SERVICE BULLETIN

N° **139-731**

ATA 00 – FORWARD CABIN ROOF CEILING HARNESS INSPECTION

This Service Bulletin is issued in order to prescribe one-off inspections of the Forward Cabin Roof Ceiling Harnesses and their installation in the area between STA 3120 and 3900 to identify potential chafing conditions.

Figure 1

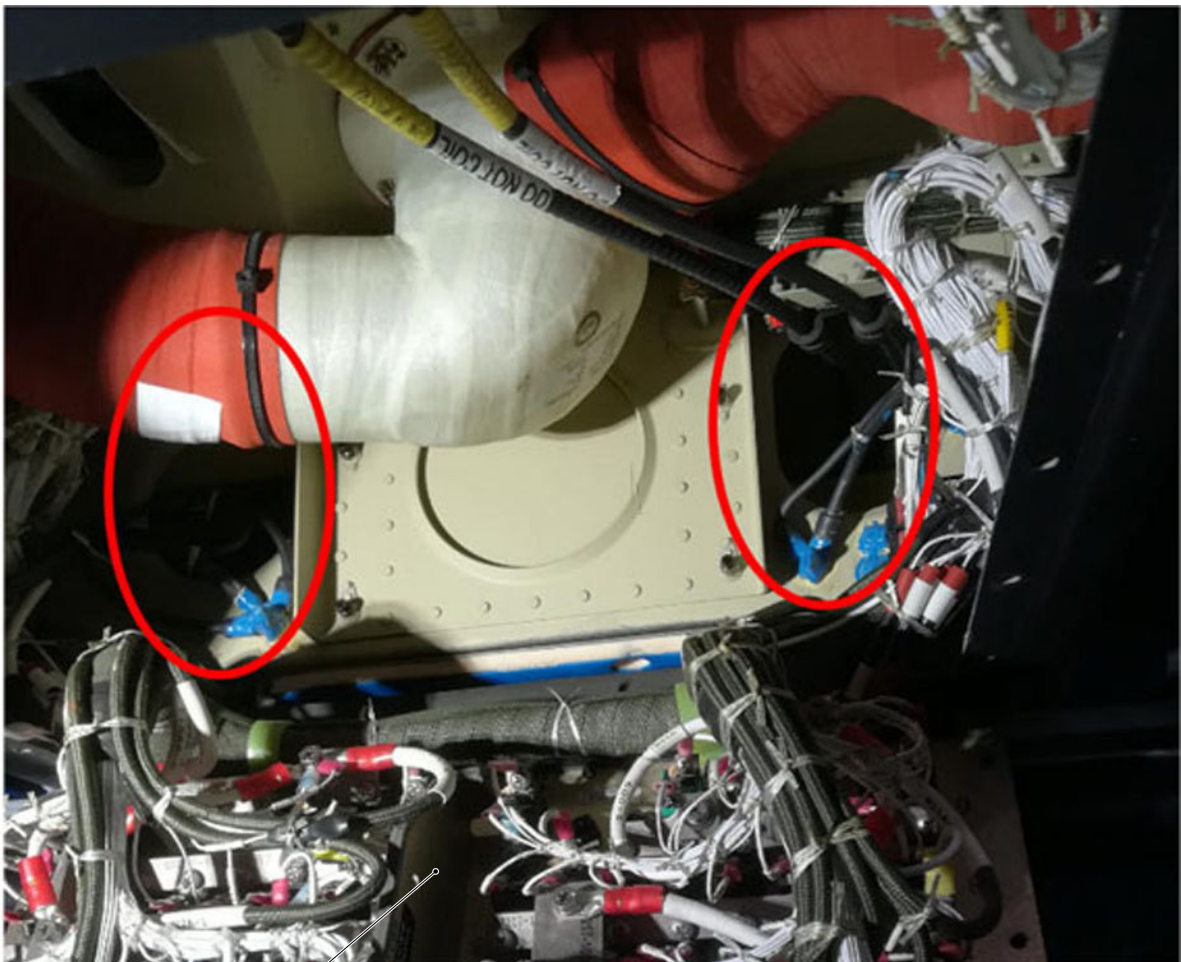
- 2.1.1 In accordance with the applicable steps of AMP DM 39-A-24-91-01-00A-520A-A and with reference to Figure 1, open the circuit breaker panel assy without removing it.

- 2.1.2 With reference to Figure 1, insert the borescope inside the lightening holes showed to access the area of the inspection.
 - 2.1.3 Perform a visual inspection of the C/As installation.

Figure 3

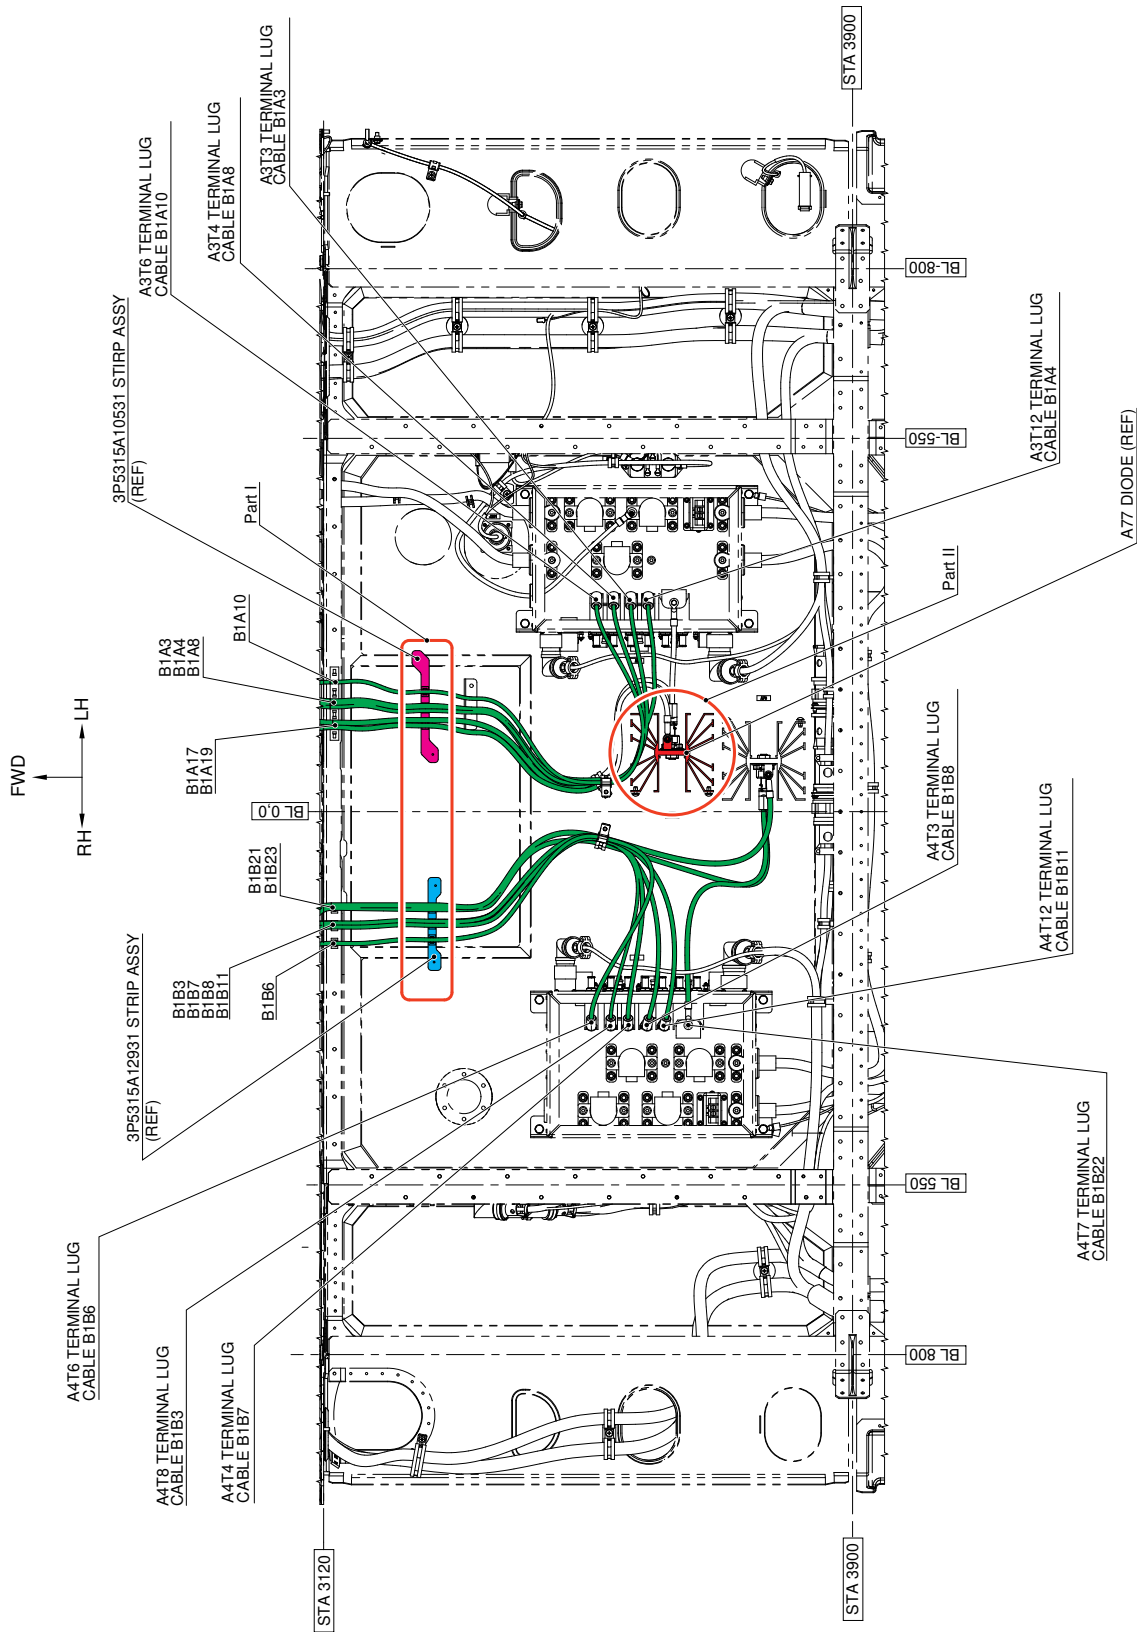
When C/A installation is correct, C/A are installed below the RH/LH strips P/N 3P5315A10531 and P/N 3P5315AA12931, as shown in Figure 3.

- 2.1.4 If C/As are installed above the strips P/N 3P5315A10531 and/or P/N 3P5315A12931 as per Figure 4 “Incorrect Installation”, go to step 3.
- 2.1.5 If C/As are installed correctly as shown in Figure 3, go to step 5 and close SB Part I application.

- 3.1 With reference to Figure 2 and Figure 3, perform a visual inspection of the C/As fixed to strips P/N 3P5315A10531 and 3P5315A12931 according to the following steps:

Figure 6

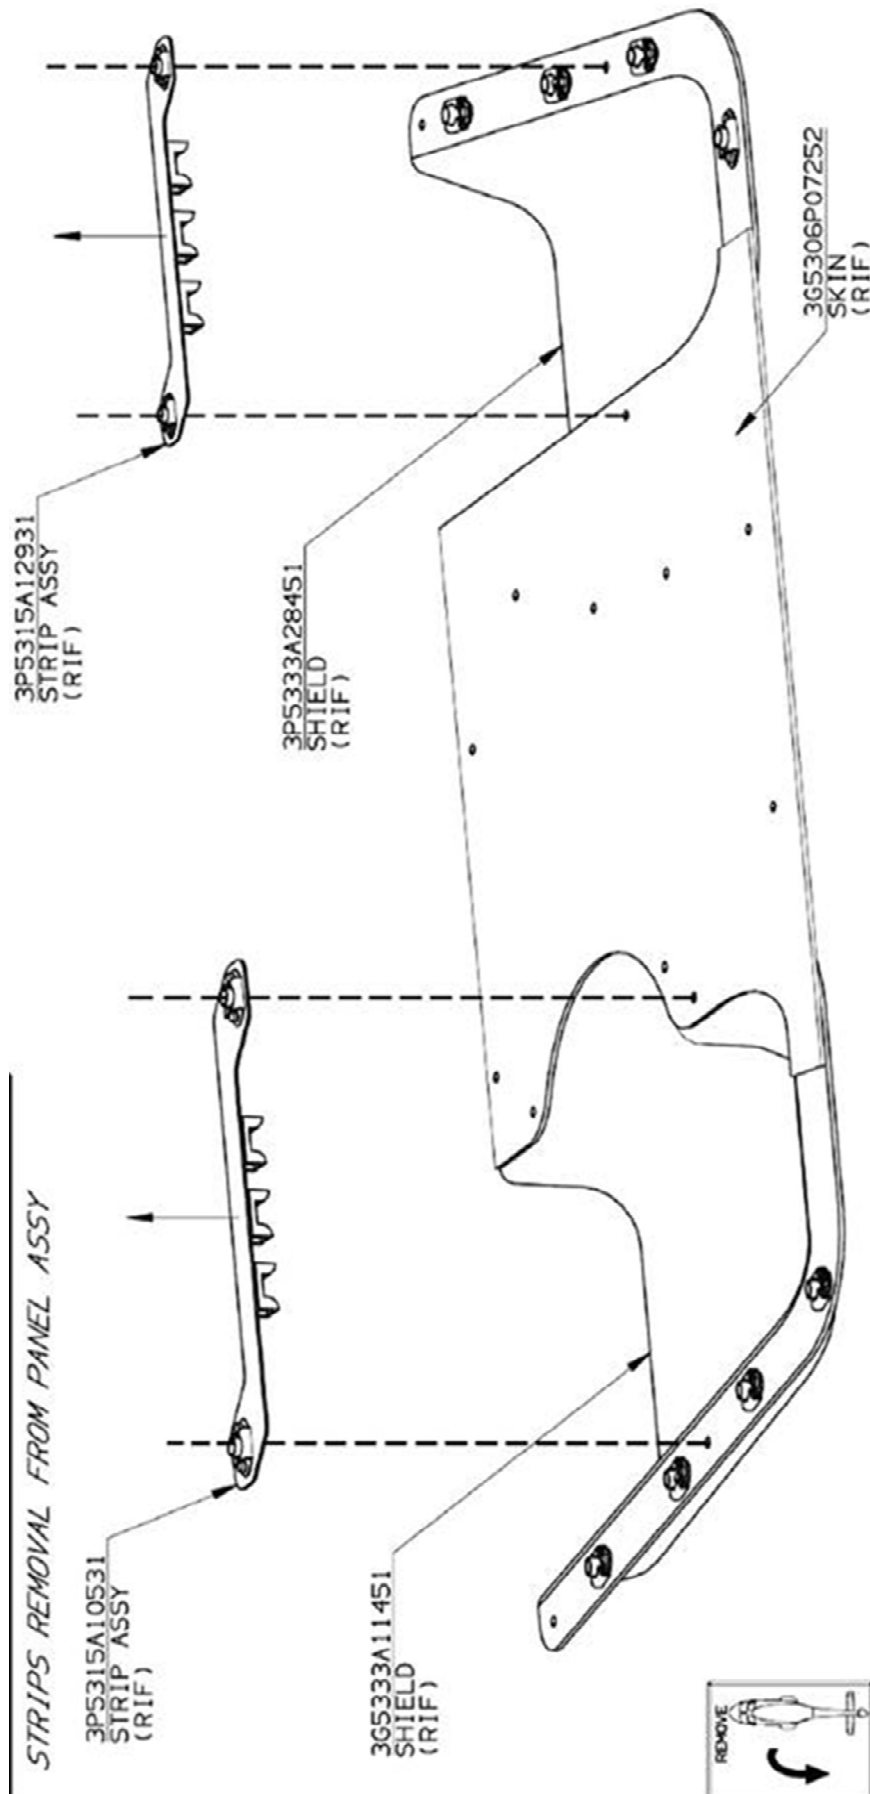
- 3.3.2 With reference to Figure 6 remove strips P/N 3P5315A10531 and/or 3P5315A12931 and put them on a workbench. Retain the fixing hardware for later use.

3.3.7 With Reference to Figure 6, reinstall strips P/N 3P5315A10531 and/or 3P5315A12931.

Figure 7

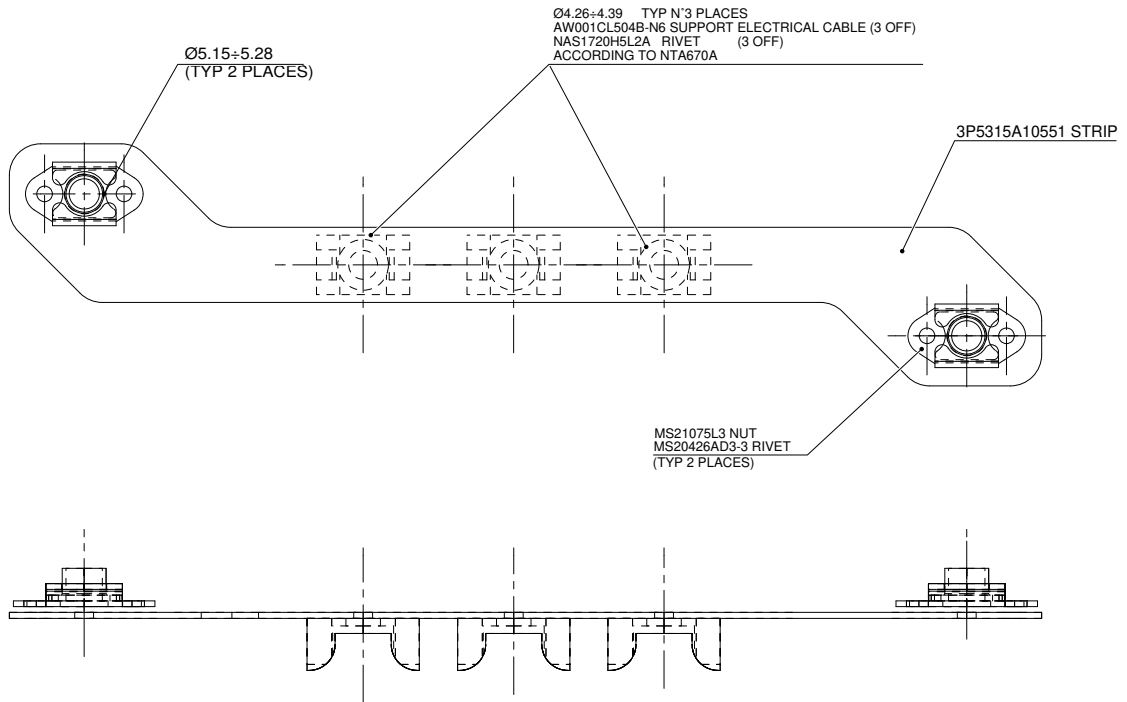
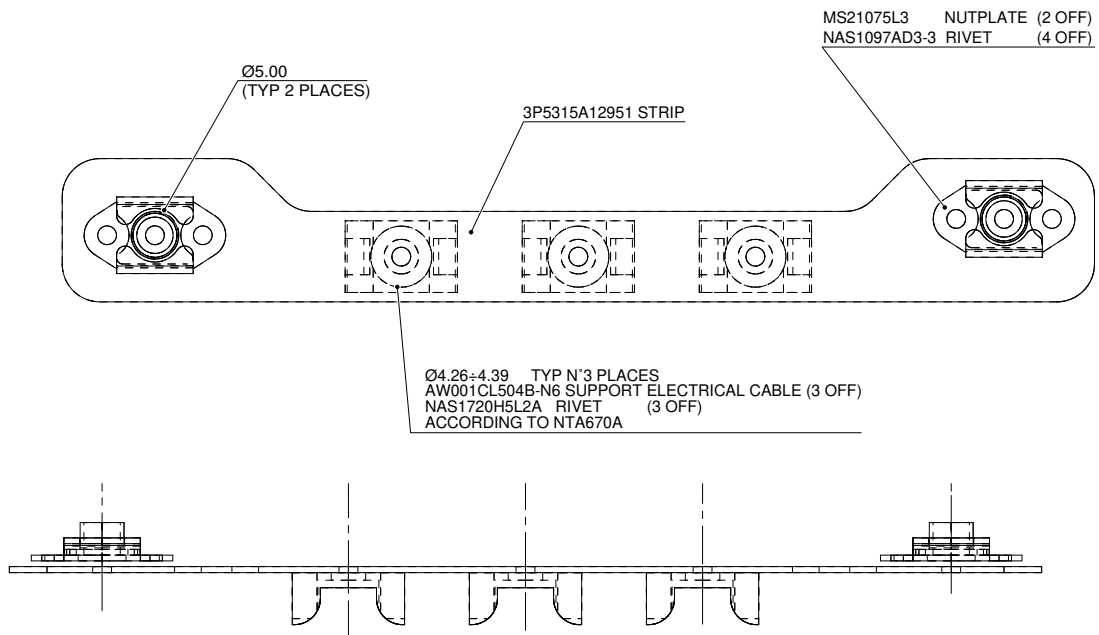
- 3.3.3 With reference to Figure 7, remove n° 3 supports AW001CL504B-N6 from P/N 3P5315A10531 and/or P/N 3P5315A12931.

- 3.3.4.4 With reference to Figure 7 install n°2 nut plates P/N MS21075L3N by means of n°4 rivet P/N NAS1097AD3-3 or P/N MS20426AD3-3 (as applicable) on strips P/N 3P5315A10551 and/or 3P5315A12951.

- 3.3.4.5 With Reference to Figure 7, install n° 3 new supports AW001CL504B-N6 by means of n° 3 rivets NAS1720H5L2A on strips P/N 3P5315A10551 and/or 3P5315A12951. Make sure they are oriented opposite with respect to nut plates MS21075L3N.

- 3.3.4.6 With reference to Figure 7, countermark the obtained components as P/N 3P5315A10531 and/or 3P5315A12931.

- 3.3.5 With Reference to Figure 7, install n° 3 supports P/N AW001CL504B-N6 by means of n° 3 rivets NAS1720H5L2A on bracket P/N 3P5315A10531 and/or 3P5315A12931. Make sure they are oriented opposite with respect to nut plates MS21075L3N.
- 3.3.6 With reference to Figure 9, fix C/As on strips P/N 3P5315A10531 and/or 3P5315A12931 by means of tie wraps.

Figure 8

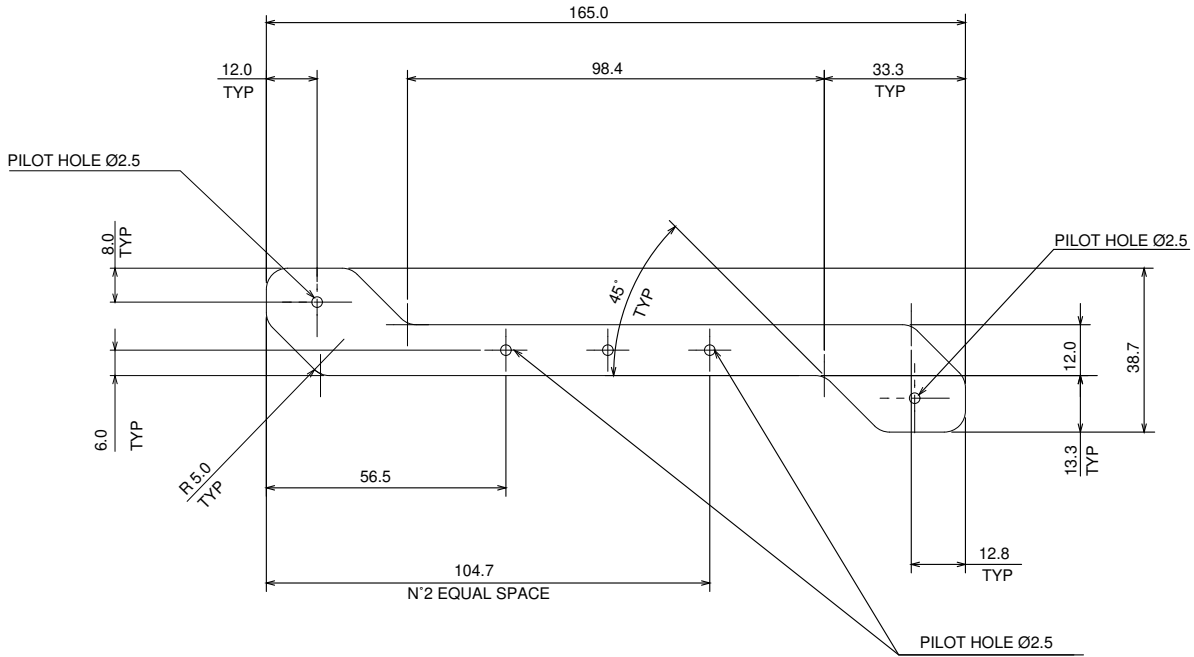
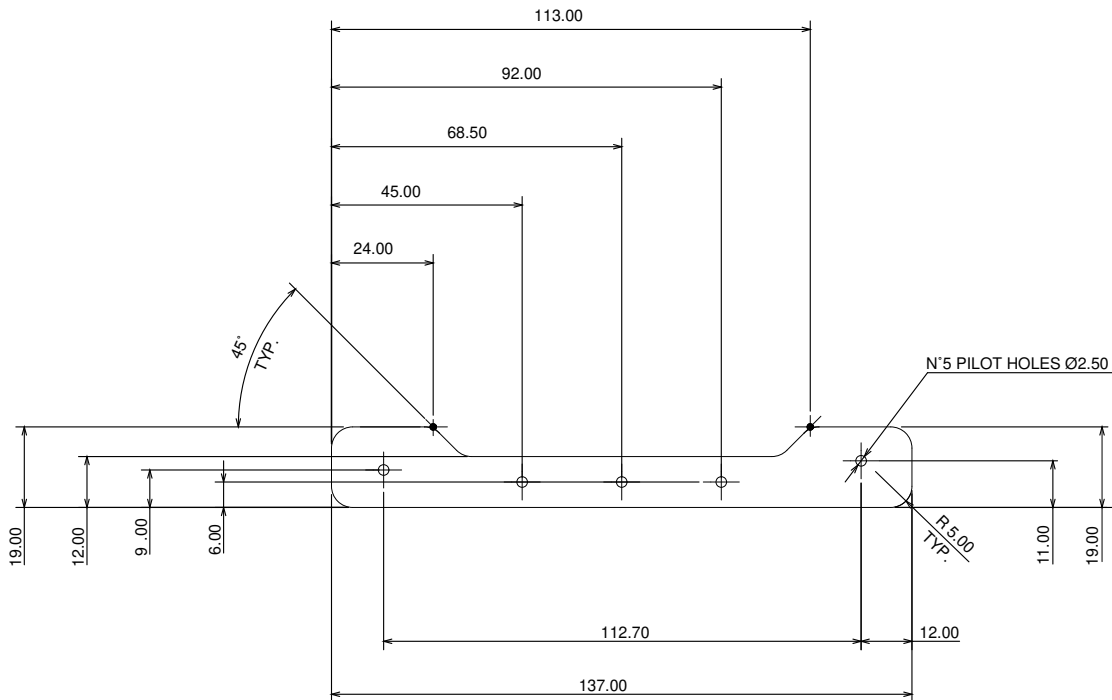
- 3.3.4 With reference to Figure 7, assemble strips P/N 3P5315A10531 and/or 3P5315A12931 with reference to the following procedure:
- 3.3.4.1 With reference to Figure 8, manufacture strips P/N 3P5315A10551 and/or 3P5315A12951 using Aluminium Sheet AL-ALY 2024.

- 3.3.4.2 In accordance to CSRP DM CSRP-A-51-21-06-00A-644A-D apply Chromate Conversion Treatment.
 - 3.3.4.3 With reference to Figure 8 and in accordance with CSRP DM CSRP-A-51-21-02-02A-257A-D apply a layer of primer on strips P/N 3P5315A10551 and/or 3P5315A12951.

Figure 9

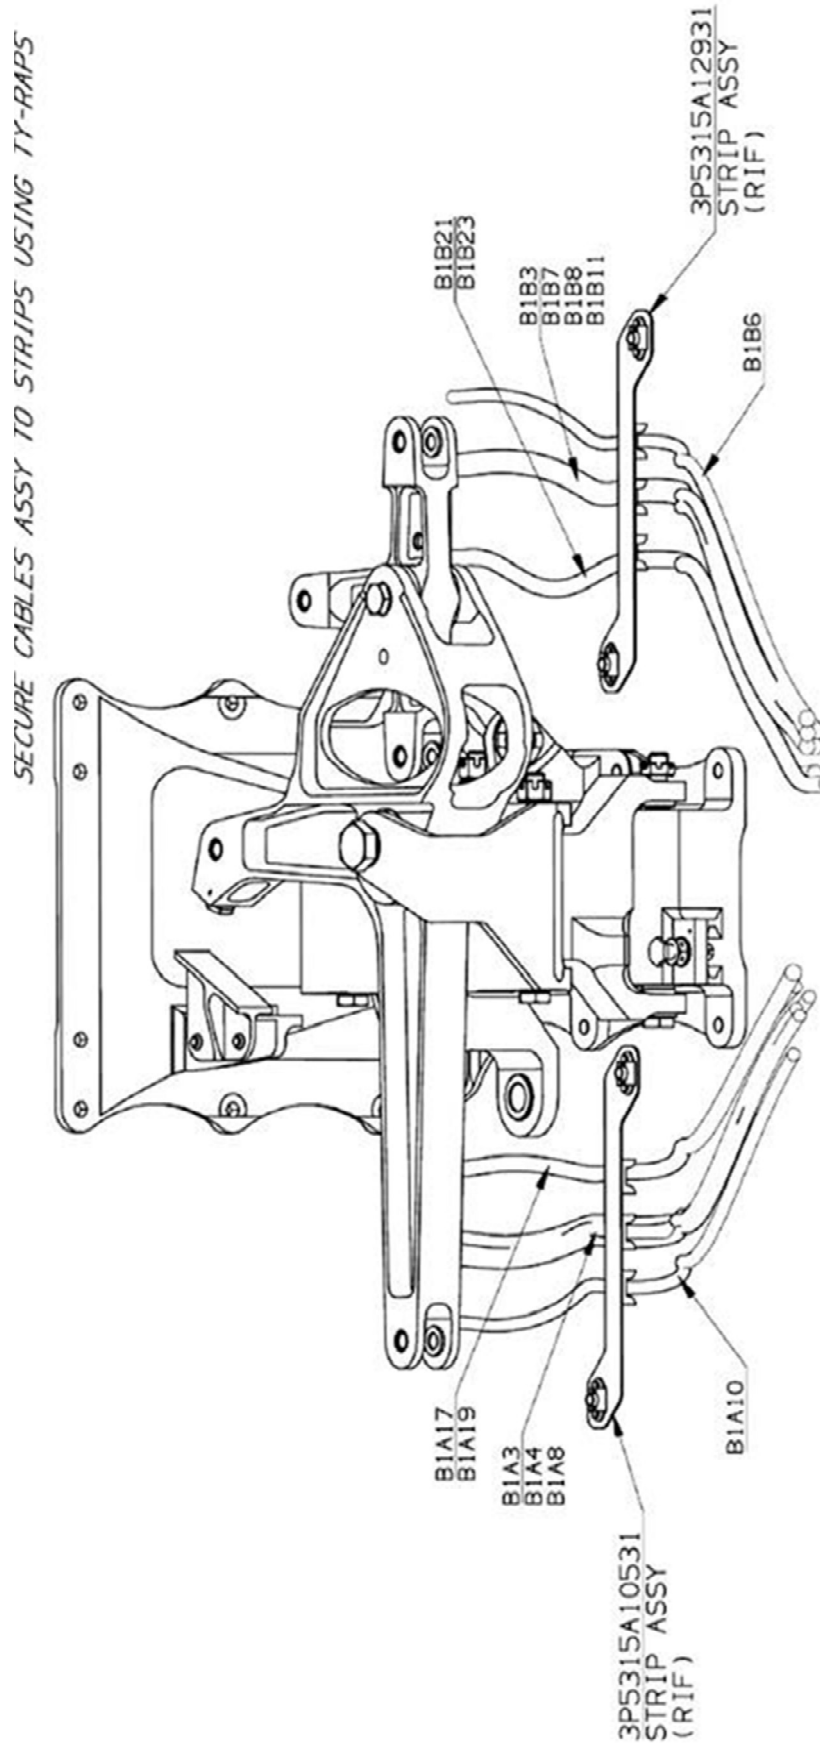
- 2.1.1 With reference to Figure 10, check for chafing or damage on the cable harness in the area showed.
 - 2.1.2 In case of any finding, contact Product Support Engineering (engineering.support.lhd@leonardo.com) in order to receive further instruction.

- 2.1.3 With reference to Figure 10 and Figure 11, ensure that clearance of at least 10.0 mm exists in the area inside the red circle shown in Figure 11, between the cable harness and Diode A77 P/N 3G2430V00352.

In case of any doubt and/or need to support, contact Product Support Engineering (engineering.support.lhd@leonardo.com) in order to receive further instruction.
 - 2.1.4 If necessary, in accordance with Figure 10 and Figure 11, re-route the cable harnesses (using if needed also lacing cord to fix the cables with each other) in order to respect the clearance of at least 10.0 mm from the diode or any other surrounding structure or component.
 - 2.2 With reference to Figure 10 and 11, perform a visual inspection of the Diode A77. Make sure that no damage is present on the component.
 - 2.3 In case of any finding, contact Product Support Engineering (engineering.support.lhd@leonardo.com) in order to receive further instruction.
3. In case of findings, contact Product Support Engineering (engineering.support.lhd@leonardo.com) to report about the results of the inspections requested.
